Project	IEEE 802.16 Broadband Wireless Access Working Group < http://ieee802.org/16 >
Title	Formats change for Figures 477 and 478
Date Submitted	2006-09-12
Source(s)	Peretz Feder - Lucent Technologies [mailto: pfeder@lucent.com]
Re:	
Abstract	This contribution proposes operator ID bit mapping
Purpose	Adoption
Notice	This document has been prepared to assist IEEE 802.16. It is offered as a basis for discussion and is not binding on the contributing individual(s) or organization(s). The material in this document is subject to change in form and content after further study. The contributor(s) reserve(s) the right to add, amend or withdraw material contained herein.
Release	The contributor grants a free, irrevocable license to the IEEE to incorporate material contained in this contribution, and any modifications thereof, in the creation of an IEEE Standards publication; to copyright in the IEEE's name any IEEE Standards publication even though it may include portions of this contribution; and at the IEEE's sole discretion to permit others to reproduce in whole or in part the resulting IEEE Standards publication. The contributor also acknowledges and accepts that this contribution may

Figure 477 – Context transfer primitives initiated by a serving BS

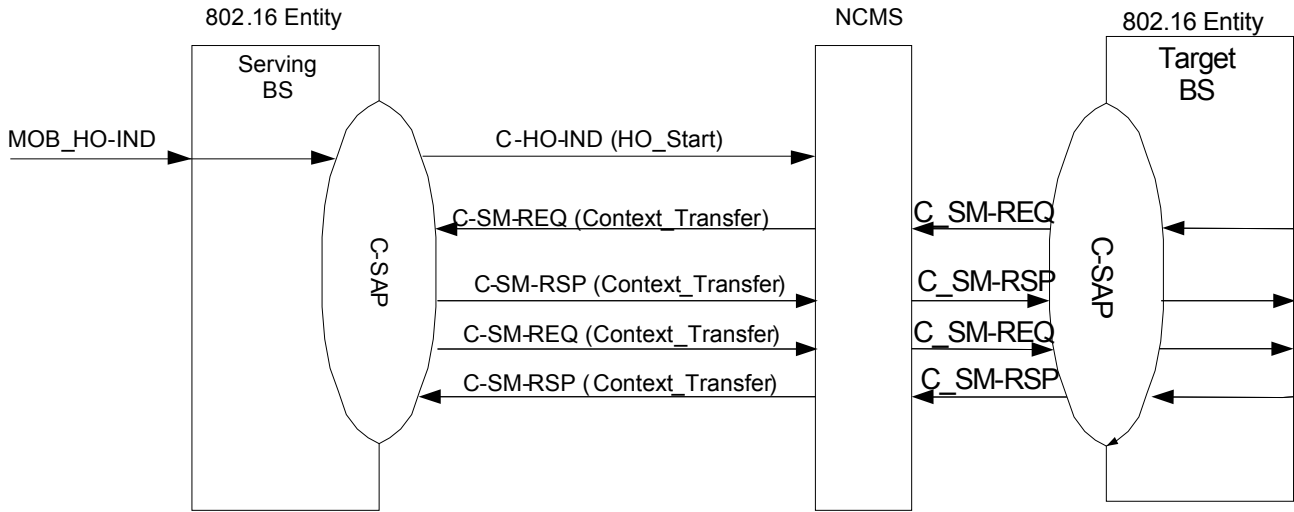
Figures 477 and 478 are hard to comprehend when combining call flows of serving and target BS within a single entity.

Split the serving and target BS and show call flow exchange through the NCMS

Split Serving BS and Target BS call flows per below:
